SUBJECT: **Working Session Memo for Petition #160-24** for SPECIAL PERMIT/SITE PLAN APPROVAL to allow retaining walls along the sides and rear of the dwelling exceeding four feet in height within the side setbacks and to exceed Floor Area Ratio at 54-56 Indiana Terrace, Ward 5, Newton Upper Falls, on land known as Section 51 Block 40 Lot 06, containing approximately 7,760 sq. ft. of land in a district zoned Multi Residence 1. Ref: Sec. 7.3.3, 5.4.2.B, 3.2.3, 3.2.10 of Chapter 30 of the City of Newton Rev Zoning Ord, 2017.

54-56 Indiana Terrace

MEMORANDUM

Re: Special Permit – 54 Indiana Terrace

Elevations

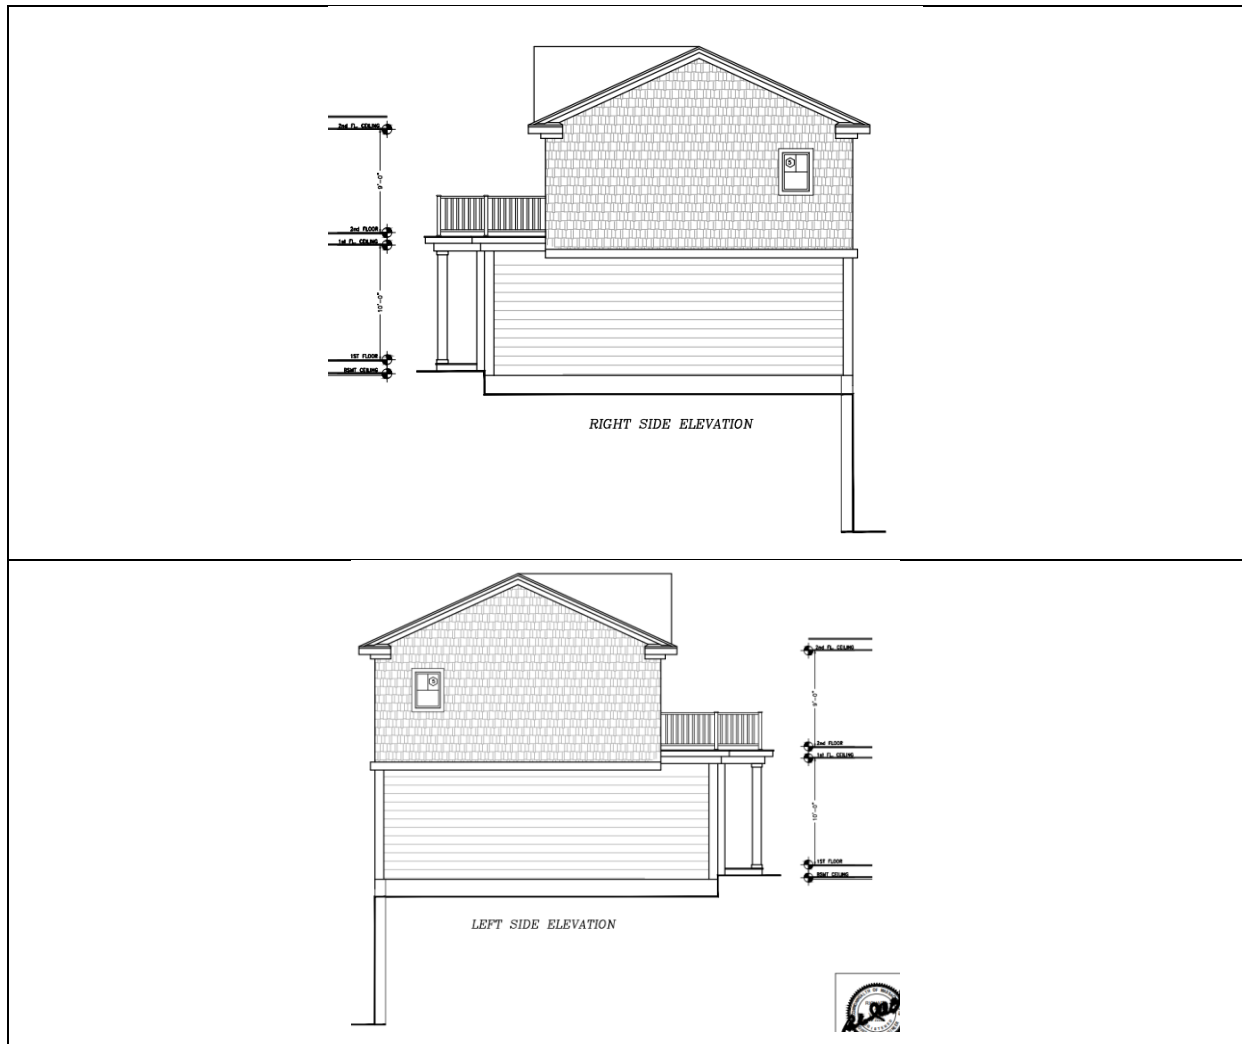
- Changes to the rear and front facades: in addition to changes to the new bays and bringing the front façade and entrances forward, the petitioners have replaced the sloped overhang between the first and second floor on the front façade with a balcony. The last of the changes to the façade of the building are the changes to the second floor front façade, which had previously had two gables that extended from the bottom of the second floor to the roofline. Instead, the petitioners shortened those gables, having them begin at the top of the second floor and extend to the roofline. Two more gables were added towards the side facades with a door and single-window on each side replacing where there have been double-windows.

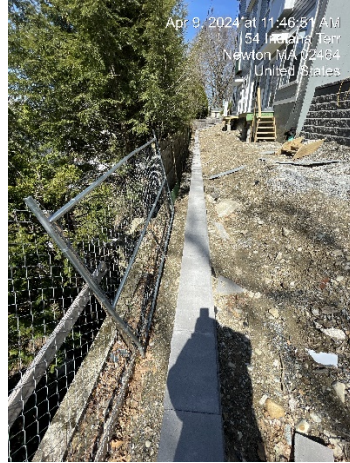
As retaining walls fall under the jurisdiction of Inspectional Service Department (ISD) they will have to determine if this is sufficient as an affidavit of retaining wall design and stability.

The site did not have any siltation controls in place and the exposed soil should be covered with some sort of silt control as it should not be exposed for prolonged periods.

Walls over 3 feet must have a safety fence along its entire length.
